CALIFORNIA
NATIVE PLANT SOCIETY

March 19, 2018

Re: Paradise Valley Specific Plan SCH #2015101031; SP 339; GPA 686; CZ 6195; EIR 506 and Draft Environmental Impact Report

Figure 1: Active Floodplain for Arid West Delineations (from Figure 1 of Curtis and Lichvar 2010¹⁴)

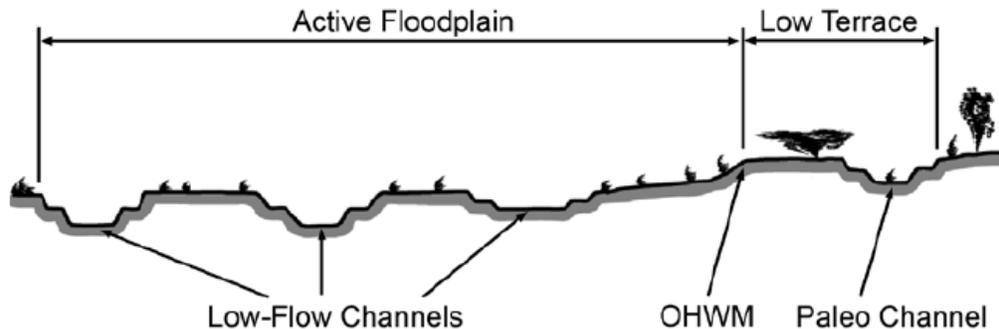
Overall, it appears that only the low flow channels were delineated as the jurisdictional areas of Waters of the United States found on the project site. However, the Corps procedures for determining the Ordinary High Water Mark (OHWM) in these episodic drainages documents that the active floodplain defines the Waters of the US, and not the low flow channels. As noted in the field manual, the “OHW zone in low-gradient, alluvial ephemeral/intermittent channel forms in the Arid West is the active floodplain. The dynamics of arid channel forms and the transitory nature of traditional OHWM indicators in arid environments render the limit of the active floodplain the only reliable and repeatable feature in terms of OHW delineation” (Lichvar and McColley 2008¹³).

Figure 2: Episodic Channel, Hydromorphic Units (From Figure 1 of Curtis et al. 2011¹⁵)

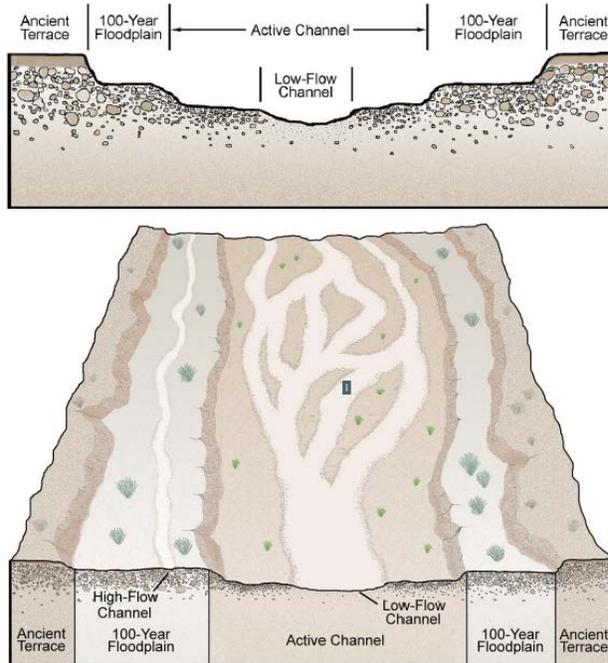
It was noted that a large area of these episodic channels were delineated as potentially jurisdictional for the 1600 agreement from CDFW. However, it is apparent that this study did not use the MESA procedures (CEC 2014) for delineating episodic stream channels, especially Appendix G Mapping Episodic stream activity. The MESA guide notes that the jurisdictional area will be the active watercourse in these episodic channels, which is at a minimum assumed to be the active floodplain of the episodic channel. The definition of the active channel for these delineations will include the 100-year flood plain vs. the Corps procedures which do not include these areas in their concept of the active channel. It does not appear that the entire CDFW jurisdictional areas were included in the CDFW Waters delineation on the project site, and the total jurisdictional CDFW acreage may have been underestimated in the studies performed for this project. As a result, it is highly recommended that the delineation report be revised before the completion of the FEIR. This would potentially provide a more accurate determination of the potentially jurisdictional episodic waters found on the project site. Additionally, we would like to recommend the following:

- Prepare a detailed methods section for the revised version of this report that would document how the active floodplain within the study area was determined for this study. More details should also be provided on the data collected on each transect across these episodic channels, and the OHWM data sheets should have been included in an Appendix to this document. This section should
